Re: Exterior Modifications to 150 Tait Avenue

**Project Address:**  
150 Tait Avenue, Los Gatos, CA

# Exterior Design & Materials

## VIII. Proposed Siding

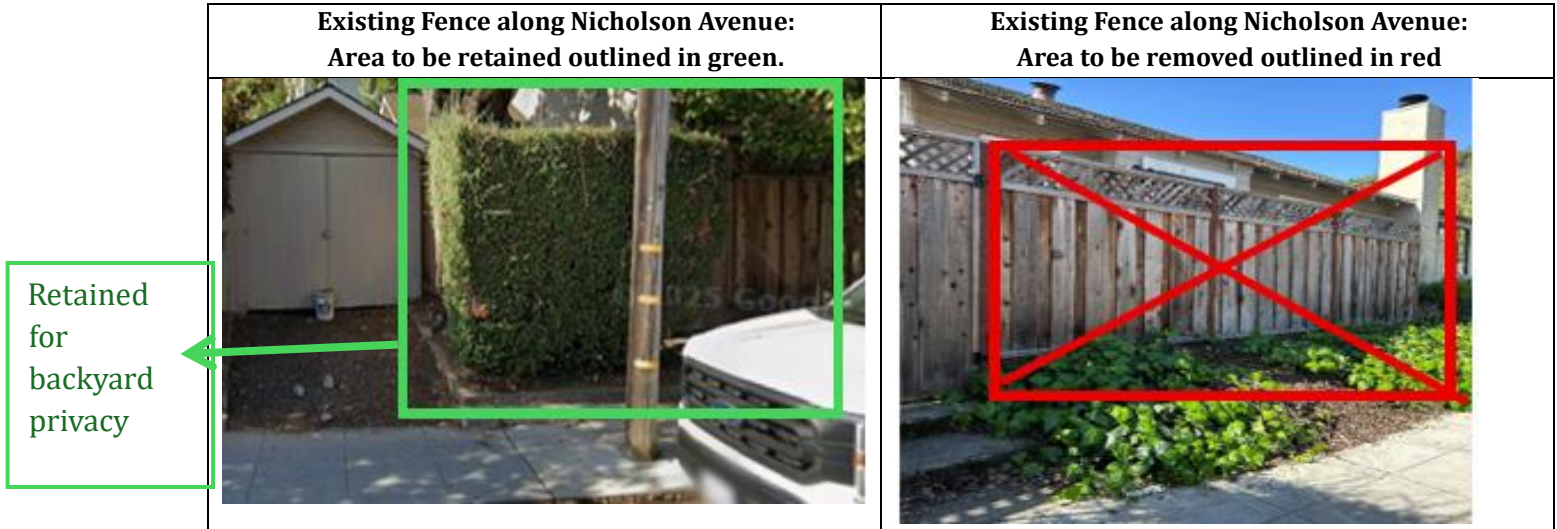
1. **Corbels:** The corbels are acceptable;
2. **Plan Consistency:** When resubmitting the formal plans make sure the plans are consistent; and
3. **Siding:** On the proposed main house use the same type of siding as found on the existing garage.
4. **Porch:** Though not mentioned in the HPC's Action Letter, the HPC also recommended I consider like for like wood boards in lieu of concrete for the porch base.

With regard to the siding, I would like to proceed with the proposed fiber-cement Hardie board horizontal lap siding installed to match the existing siding's exposure, reveal and profile. As mentioned in my March 19, 2026 letter to the HPC, the existing siding profile, though not original to the home, offers a classic and charming look that fully aligns with the style of 1920s cottages. Additionally, the use of fiber cement

The existing siding will be removed and replaced with smooth fiber-cement horizontal lap siding, installed to match the existing shadow lines, scale, exposure, reveal (approximately 4-3/4" to 5"), and profile of the existing wood siding. Installation will also include a continuous weather-resistant barrier over exterior sheathing.

**C. Installation Method:** Horizontal siding with smooth fiber-cement horizontal lap siding installed to match the existing exposure, reveal (approximately 4-3/4" to 5"), and profile of the existing wood siding. Installation will also include a continuous weather-resistant barrier over exterior sheathing.
